Determination 2017/007

Regarding the authority's refusal to issue a building consent for a new house at 99B Forfar Street, Mosgiel, Dunedin

Summary

Figure 1: Footing detail (not to scale)

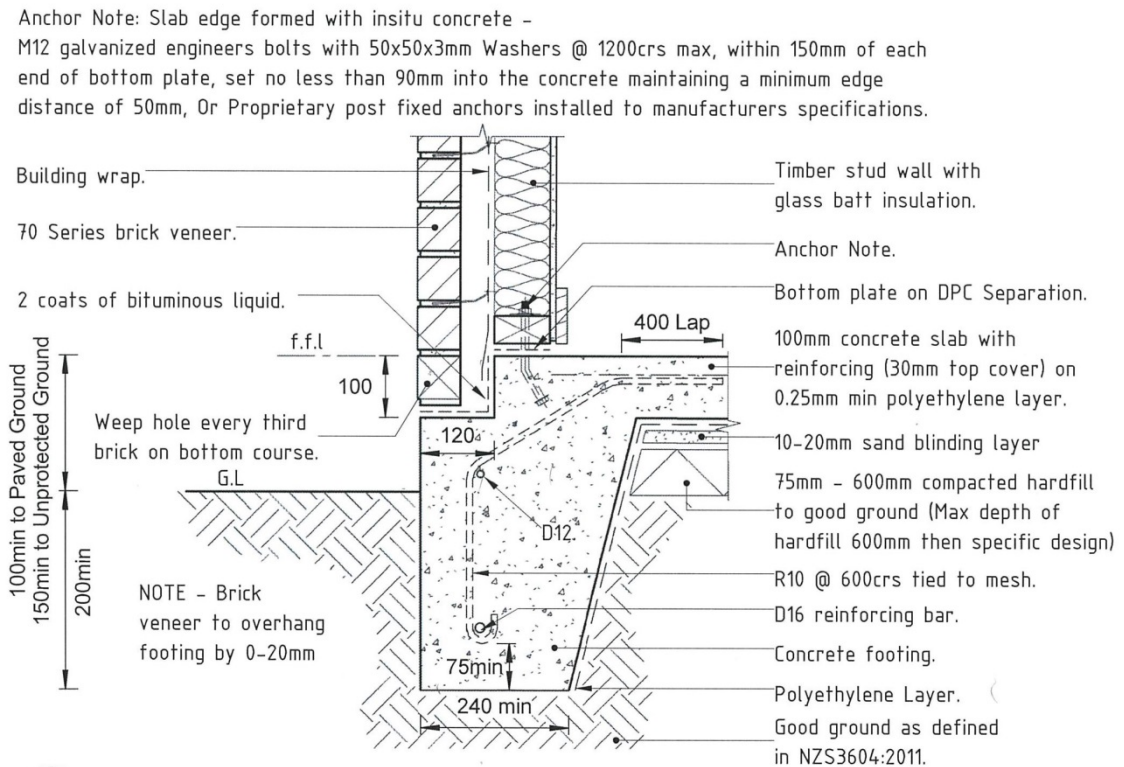
NZS 3604 requires a minimum of 2 D12 to the base of a concrete footing, refer to Figure 7.15(b) of NZS 3604 2011^[refer Appendix A.1]. The use of one bar to the base of the foot had been deleted from the standard in August 2011.

2.4 The applicant responded on 29 November 2016, noting that the footing detail was being accepted by other building consent authorities. The authority did not accept the response and the issue remained unresolved.

3.1 In conjunction with a completed application form, the applicant provided a brief submission on the matter, noting that the detail was based on Figure 3.1.6 from the Acceptable Solution SH/AS1⁴ (refer Appendix A.2) with the D12 reinforcing bar replaced with a D16, and the R6 starters replaced with R10 starters at 600 centres. The applicant acknowledged that the proposed building did not fall within the scope of SH/AS1, but noted that this was only due to the eaves being less than 650mm

- 4.4 In making a comparison with the Acceptable Solution, SH/AS1, I note the following:
 - The detail in Figure 3.1.6 of SH/AS1 shows a single D12 bar in the bottom of the footing whereas the proposed detail uses a single D16 bar; the foundation beam in the proposed detail has twice the flexural capacity (vertically and horizontally) of that in SH/AS1.

- The stirrups in the proposed detail have nearly three times the area of the stirrups in the detail provided in SH/AS1, and as the spacing is the same as for SH/AS1 the shear capacity of the proposed detail will be significantly greater.

- 4.5 In making a comparison with the Acceptable Solution B1/AS1, which in turn cites NZS 3604, I note the D16 horizontal bar in the proposed detail has a cross-sectional area of almost twice that of a single D12 bar in Figure 7.15(B) of NZS 3604. This means the proposed foundation beam has a vertical flexural capacity for resisting soft spots at 90% that of the 2x D12 bars and a horizontal flexural capacity greater than the detail in Figure 7.15(B).

4.6 Taking into account the above, I have reasonable grounds on which to form the view that the proposed foundation detail will comply with Clause B1 of the Building Code, and accordingly I conclude that the authority incorrectly exercised its powers in refusing to grant the building consent with respect to the foundation detail.

5.1 In accordance with section 188 of the Building Act 2004, I hereby determine that the authority incorrectly exercised its powers in refusing to grant building consent with respect to the proposed foundation detail described in this determination.
